Final Report

Alaskan Way Viaduct Independent Technical Review

Prepared for
Seattle Department of Transportation

April 10, 2015

FIGURE 2-6
Structure Settlement – Bents 88 to 121 (From As-Built Elevation to March 2015)

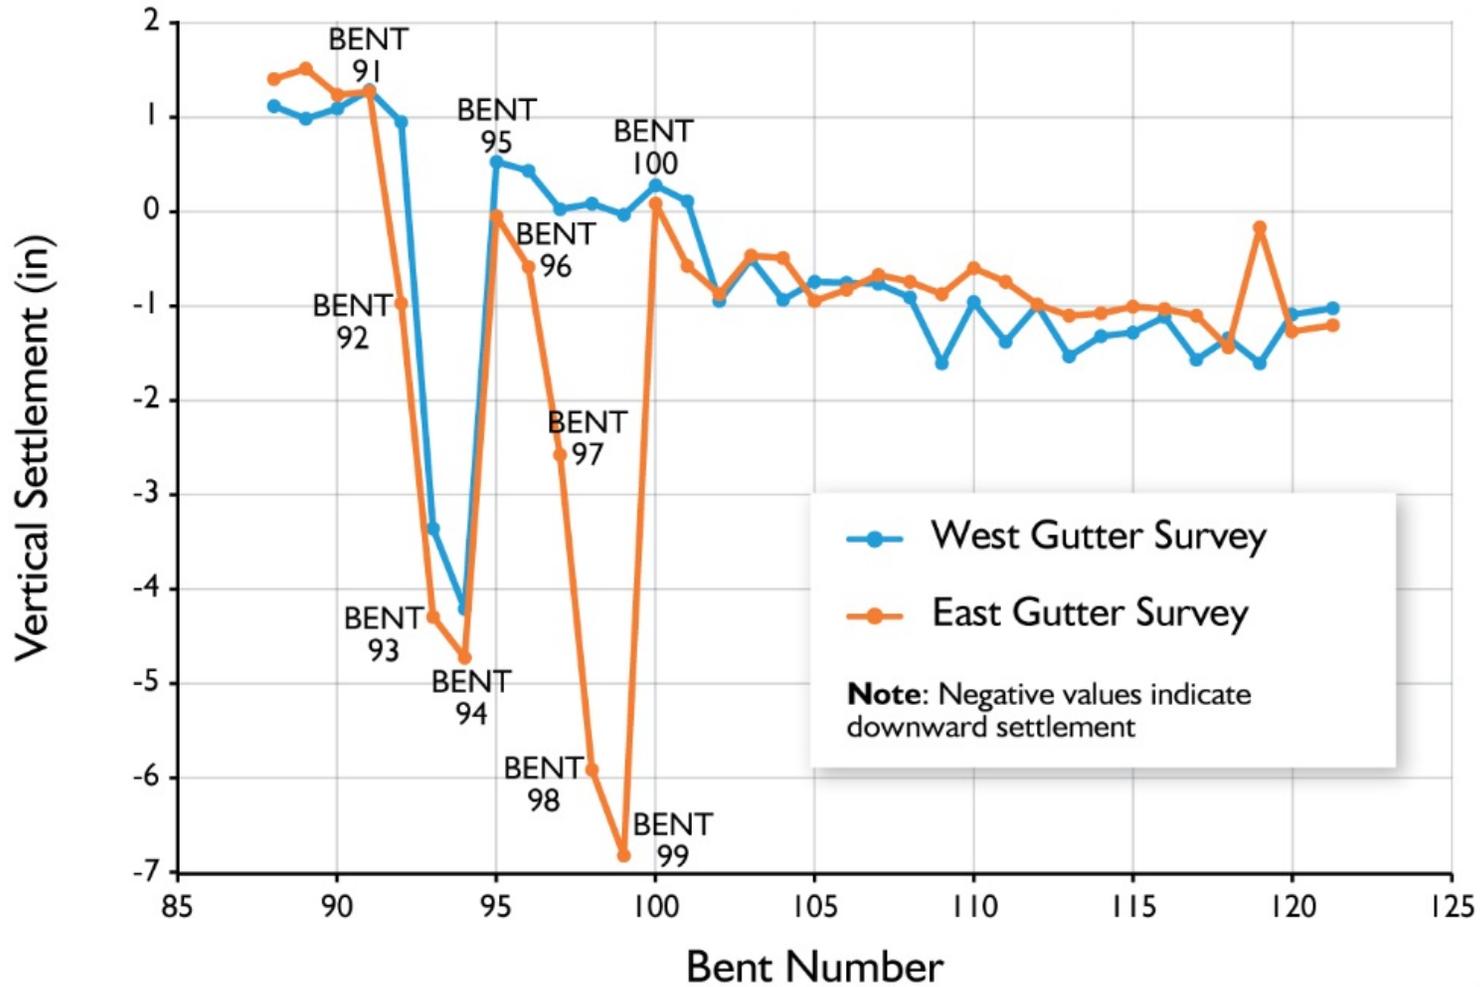
Because of the significant historical settlements that have been experienced by this portion of the viaduct that are shown in Figure 2-6, STP performed a step-by-step structural analysis both to establish the condition of the viaduct at the time when the analysis was performed (2011) and to predict the anticipated structure response due to tunneling settlement.

The straddle bents at the western end of the ramp structures are more sensitive to transverse differential settlement because at these locations the ramp is supported by a rigid frame. The settlement assessment by WSDOT's consultant for Bent 6 of the Columbia Street Ramp included consideration for 4 inches of historical vertical differential settlement, which is evidenced by the small downward settlement at mainline Bent 92, which shares the foundation with the north column of Bent 6 of the Columbia Street Ramp, and the much larger settlement at Bent 93, which is adjacent to the south column of Bent 6. These settlements are shown in Figure 2-6 and are corroborated by inspection reports.

FIGURE 3-3
Structural Evaluation and Retrofit Procedure Performed by STP – Bents 91 to 100

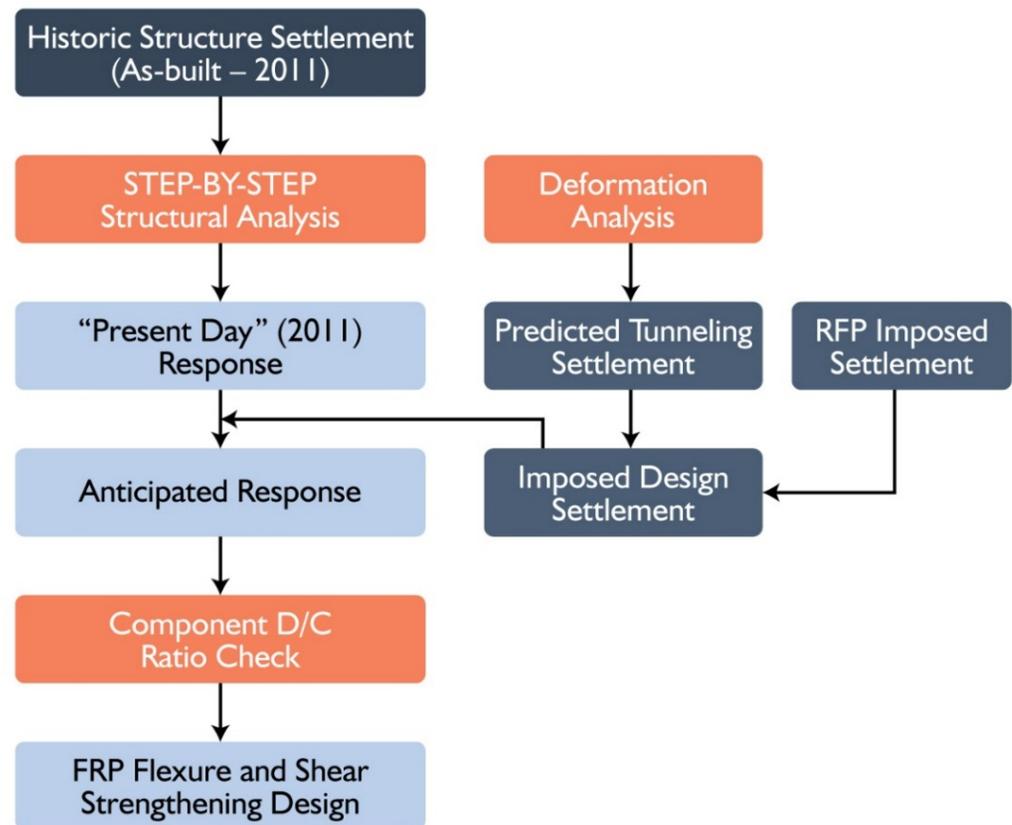
The review identified some issues in the structural evaluation performed by WSDOT's design-build contractor, STP. While the basic assumptions and the overall analysis approach appear to be reasonable, the review has raised questions regarding the structural modeling methods used in STP's calculations. Most significantly, the method used by STP to account for inelastic action of the structural members and the procedure for applying anticipated structural settlements has been questioned. CH2M HILL has informed SDOT and WSDOT of these issues and is currently in contact with WSDOT and STP in the process of resolving them. Although the impact of these potential discrepancies is not yet clear, successful resolution of these issues will be critical to the validation of STP's viaduct strengthening design.

The review also identified a gap in the accounting of some of the historical and current structure settlement. Because STP performed its evaluation and strengthening design in 2012, differential structure settlements that have occurred since 2011 have not been included in the structural analysis. Figures 3-4 and 3-5 show bar charts of differential structure settlements in both the transverse and longitudinal directions from January 2011 to March 2015 for gutter line and column survey data. The dark blue bars represent the differential settlements that have occurred since STP's analysis was conducted. The green bars next to the dark blue bars show the total expected differential settlements when the expected tunneling settlements are added to the observed differential settlements since 2011. At some bent locations, tunneling is expected to induce differential structure settlement in the opposite direction from that measured since 2011. In these cases, the tunneling settlement offsets the differential settlement at these particular bents and the maximum expected differential settlement is not expected to increase from present condition. As Figures 3-4 and 3-5 show, the observed and predicted maximum differential settlements at some bent locations exceed the settlement limit of 1" that STP used in the strengthening design. In the transverse direction, the maximum observed and expected differential settlement is about 1.25". In the longitudinal direction, the maximum expected total differential settlement is approximately 1.28".

STP's strengthening design of the longitudinal girders and transverse crossbeams included a safety allowance (or factor of safety). Exceeding the 1-inch design settlement has likely reduced this safety allowance, but may not necessarily pose a safety concern. It is recommended that this safety allowance be reevaluated. In addition, pending the successful resolution of the structure modeling issues discussed previously, it is recommended that this portion of the viaduct be actively monitored for both settlement and signs of structure distress. If the magnitude of the differential settlement continues to increase, or if certain signs of structure distress (such as increased cracking in the members) start to develop, remedial action may become necessary.

FIGURE 3-4
Differential Vertical Settlement in the Transverse Direction

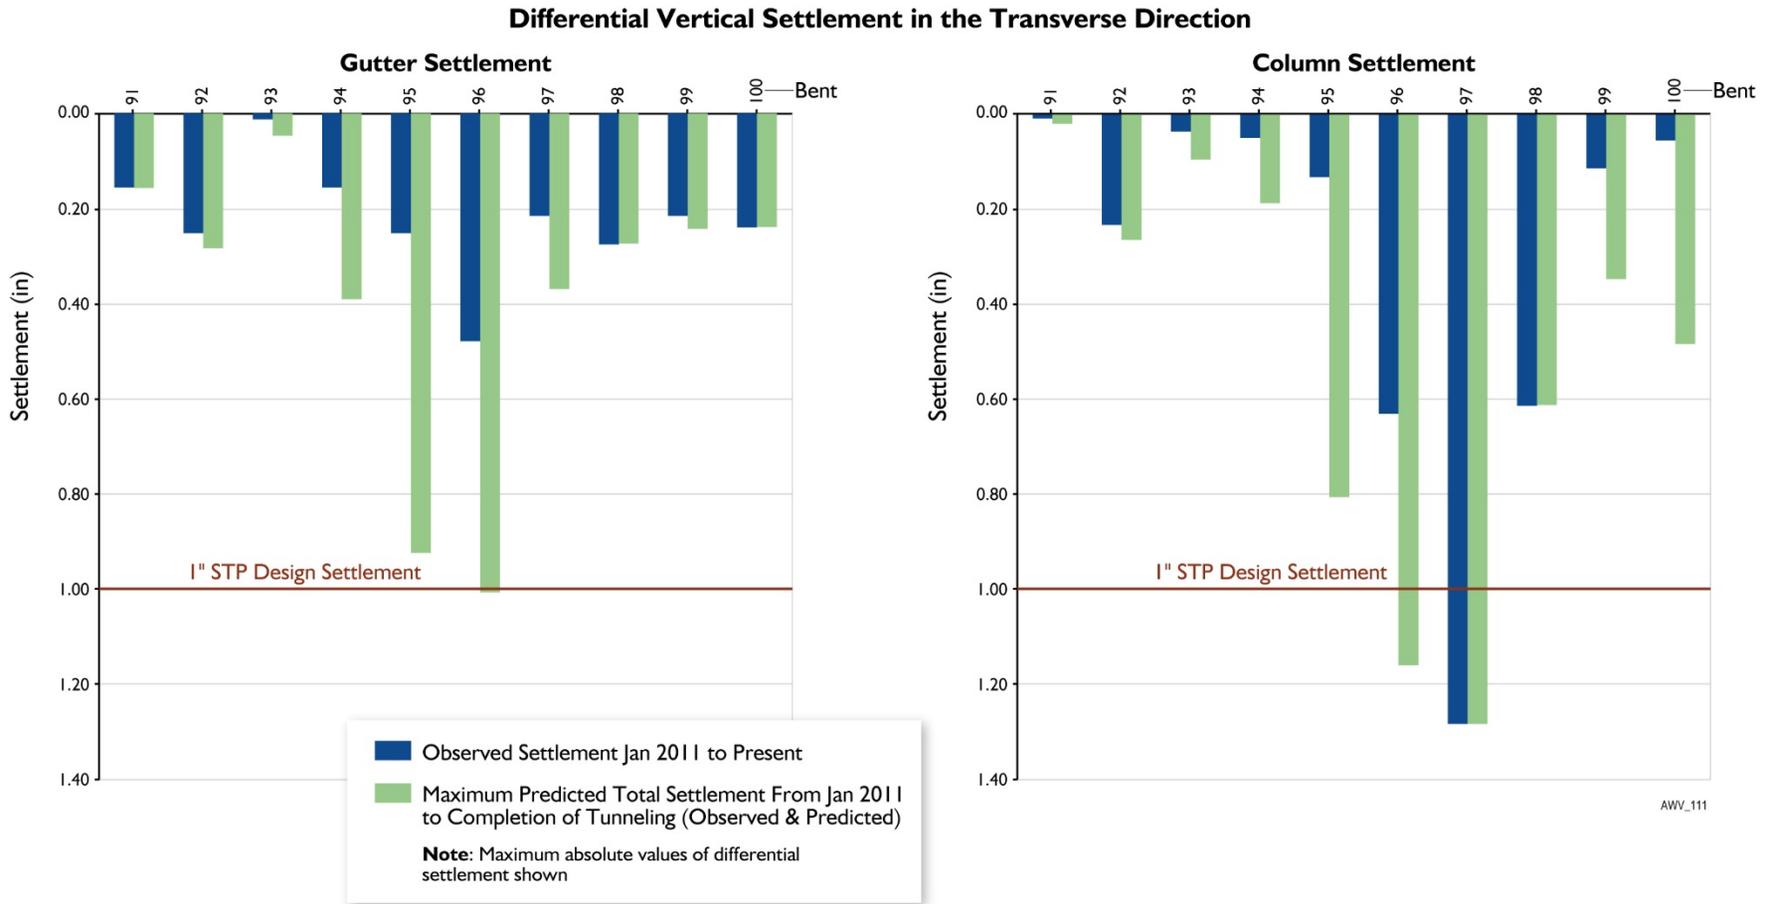
Review of available survey data found that the viaduct structure has experienced significant longitudinal and transverse differential settlement between Bents 91 and 100. The maximum magnitude of the vertical differential settlement appears to have exceeded 5 inches between Bents 94 and 95 and 6.5 inches between Bents 99 and 100 (Figure 2-6). Compared with vertical survey data, the availability of horizontal survey data is limited. Based on the horizontal survey data available, the magnitude of horizontal differential movement appears to be small.

FIGURE 3-7
Railroad Way Ramp Bents E121-W141

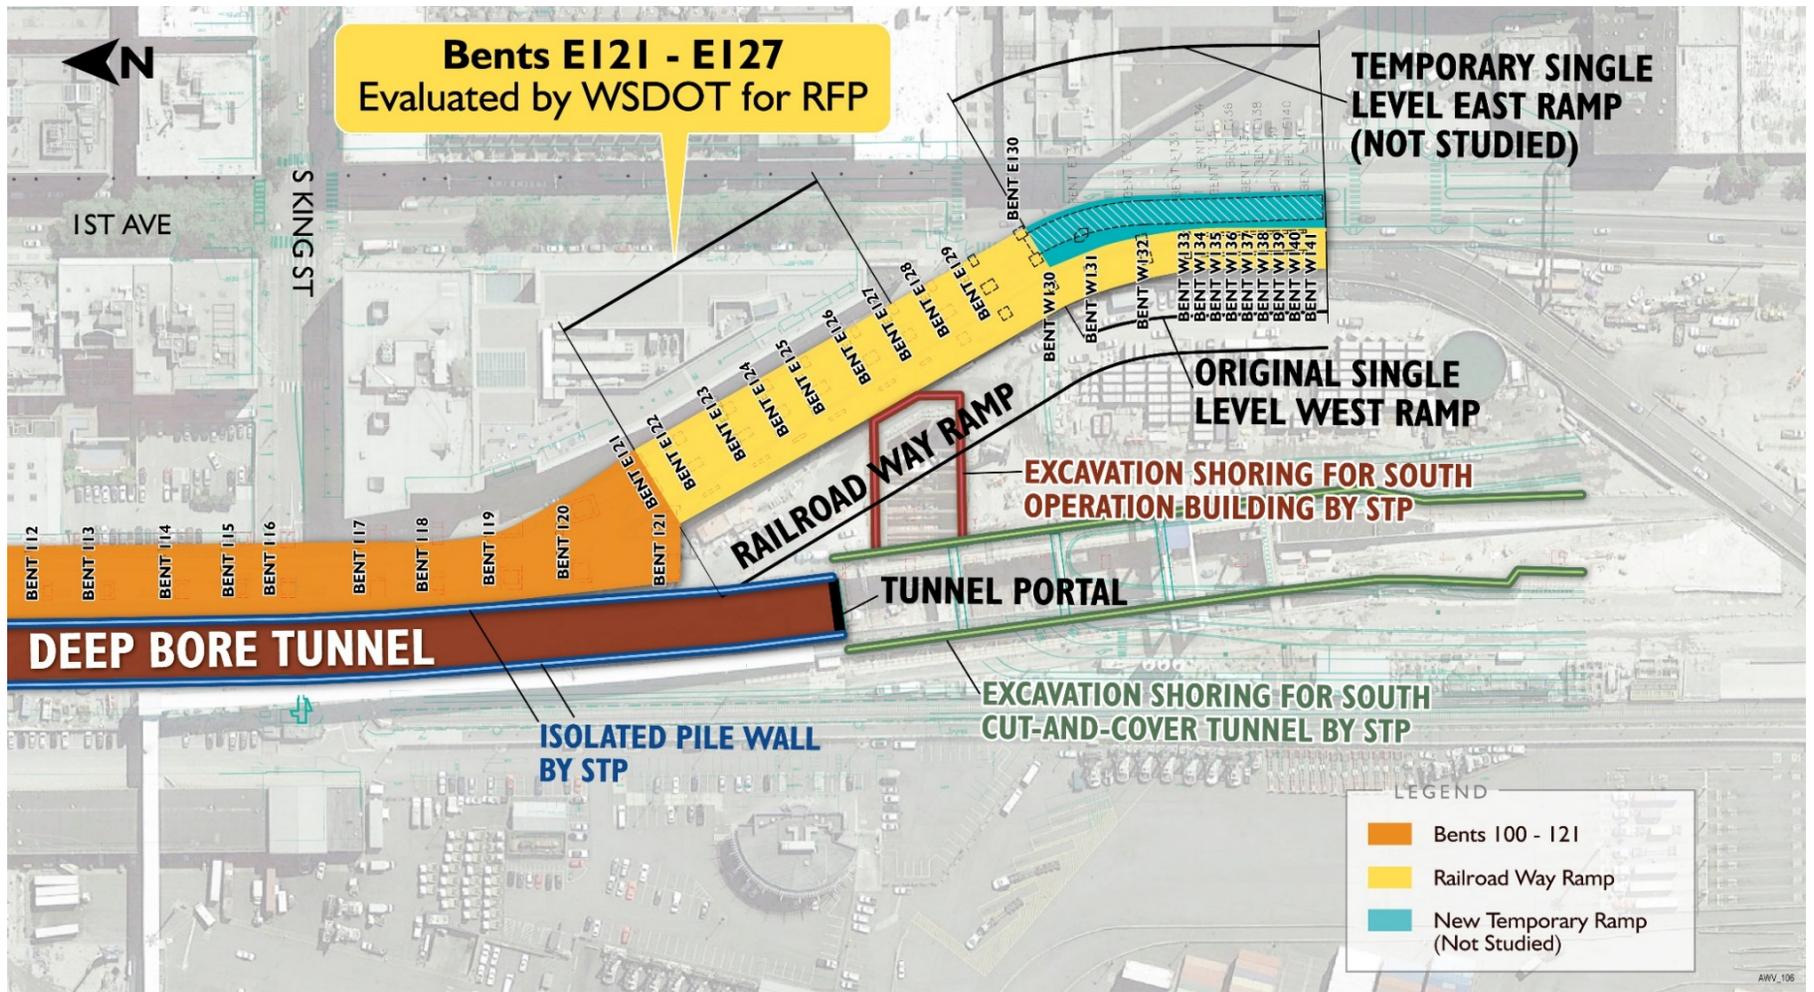
The structural assessment performed by WSDOT's consultant was based on a set of hypothetical differential settlements. The magnitude of the transverse differential settlements was 0.5-inch in the vertical direction and 0.5-inch in the horizontal direction. No longitudinal differential settlements were used in the analysis. The reason for not considering longitudinal differential settlement appears to be due to the fact that differential settlements were anticipated to be primarily in the transverse direction, resulting from excavation of the adjacent South Operation Building and South Portal (see Figure 3-7).

The assessment by WSDOT's consultant concluded that the columns and crossbeams perform adequately under these imposed transverse differential movements. Although the analysis approach appears to be reasonable, CH2M HILL's review identified several discrepancies. Of the various members of the structure, only crossbeams and columns were assessed for their structural capacity. In some cases, the reported demand-capacity ratios were not the maximum (controlling) values for a given member. Rather, a lower value was reported. However, in all cases, the unreported maximum demand-capacity ratios are still under 1.0.

CH2M HILL's review also found several gaps in the analysis. No assessment was performed for the longitudinal girders, foundations, column-beam joints, and shear capacity of columns. The analysis was also based on hypothetical differential movements in the transverse direction only. Based on available settlement data, longitudinal differential movements may also need to be considered. For the south end of the structure, between Bents E127 and E130, and W131 and W141, no assessment was performed by WSDOT. In view of the possibility of continued future settlement in this area, it is recommended that further settlement assessment be performed for this part of the viaduct to address these gaps.

FIGURE 3-10
Columbia and Seneca Street Ramps and Mainline Bents 73-91

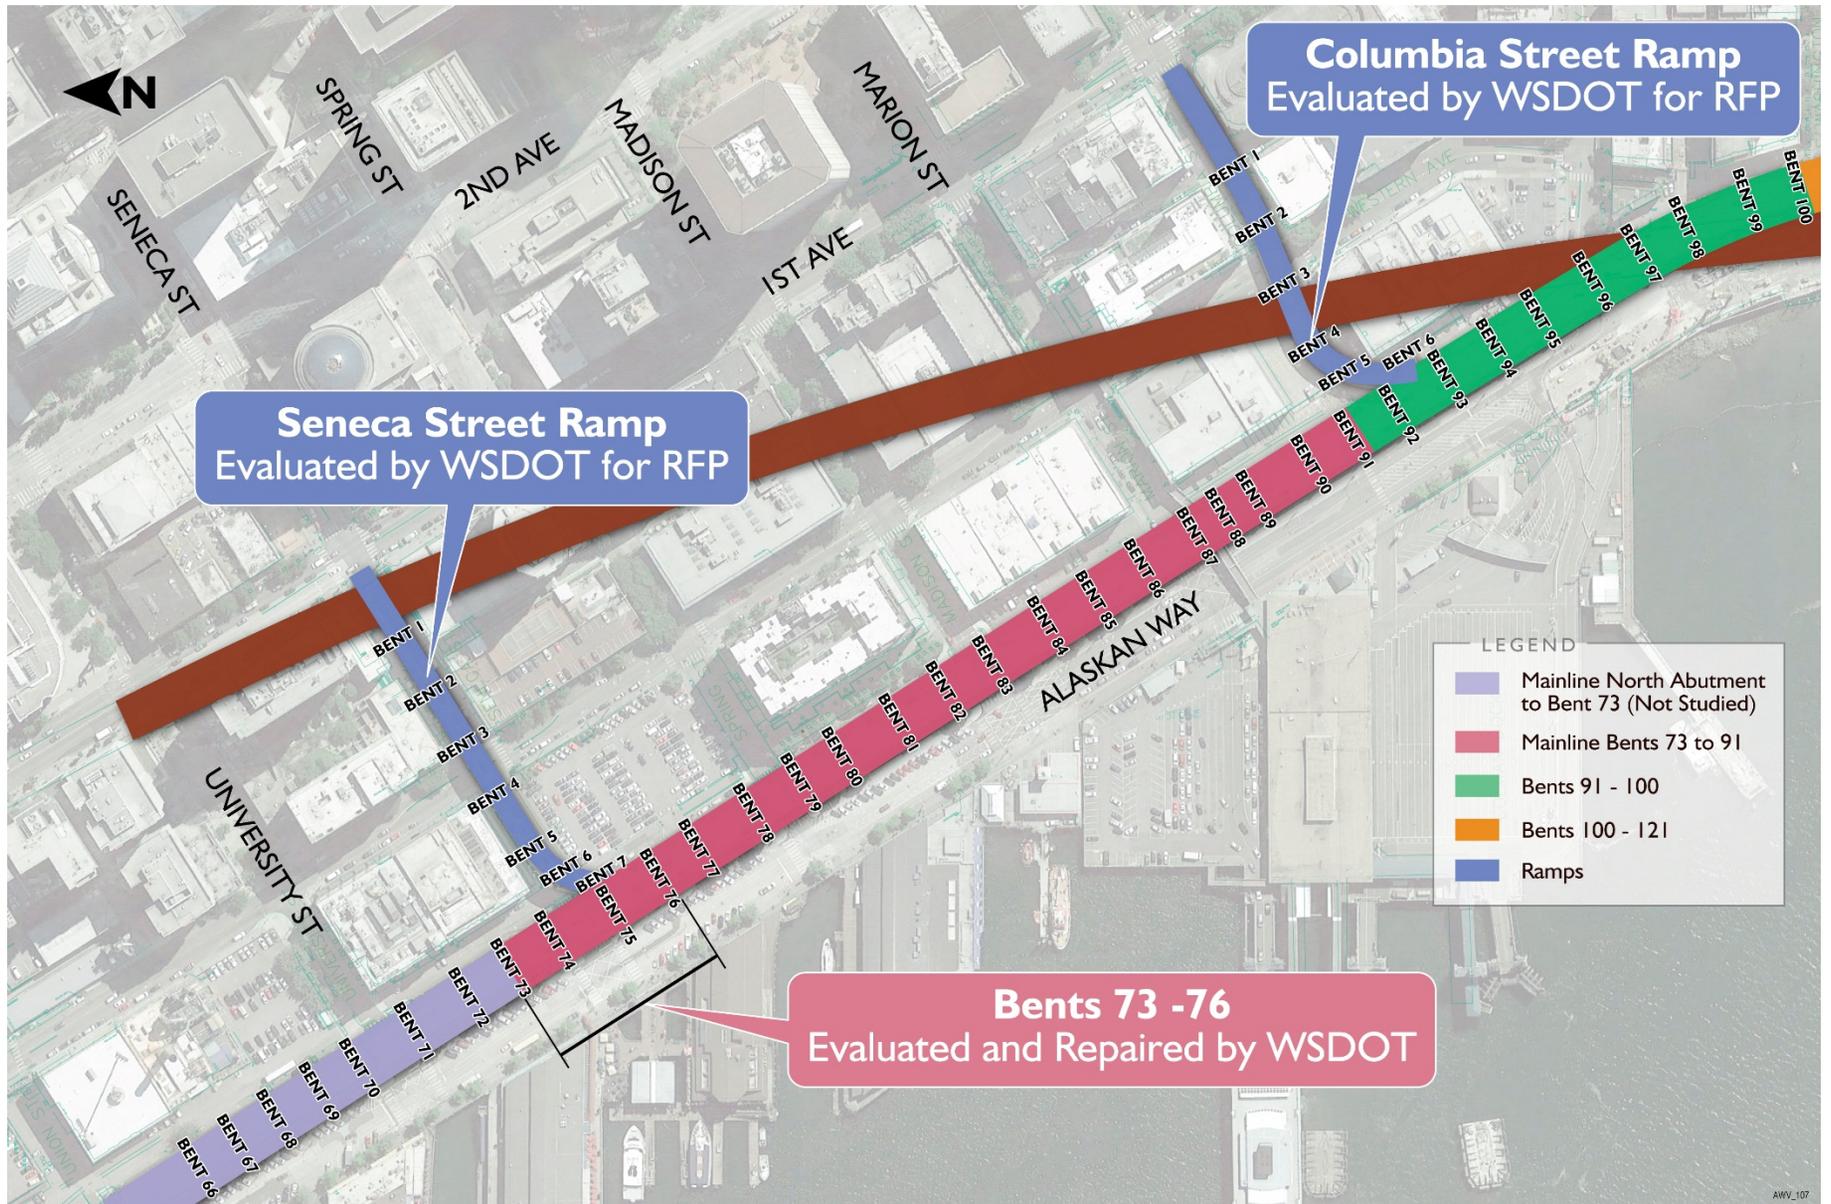
CH2M HILL generally agrees with the approach used in the settlement assessment of Bent 6 but notes that the analysis did not include evaluation of the foundations nor several potential critical shear locations in the crossbeam. A cursory check of these critical locations seemed to suggest that the

controlling demand-capacity ratios due to the historical differential settlement could slightly exceed 1.0 when using nominal material properties. When taking into account the actual material properties, it is likely these demand-capacity ratios would be less than 1.0, which is generally considered as the upper limit for adequate capacity. It appears that the structure has sufficient capacity to resist the demand resulting from settlement observed to date. Furthermore, WSDOT inspects the condition of this bent on a regular basis and has not reported any significant signs of distress or cracking.

The predicted tunneling settlement at Bent 6 is relatively small compared with the historical settlement and does not appear to be a significant concern. It is recommended that this bent to be actively monitored. Should the differential settlement at Bent 6 continue to increase, further evaluation may be necessary.

WSDOT's consultant did not perform a structural assessment of the two straddle bents at the Seneca Street Ramp. There was reported historic settlement in the vicinity although the magnitude of such settlement is unknown. No report of significant structure distress or cracking was found in the inspection reports. Moreover, due to the distance of the west end of the ramp from the proposed tunnel alignment, this portion of the ramp is located outside the zone of influence for tunnel-induced settlement. It is recommended that the settlement at Bents 6 and 7 of the Seneca Street Ramp to be actively monitored. Further evaluation may be required if the magnitude of the differential settlement becomes significant.
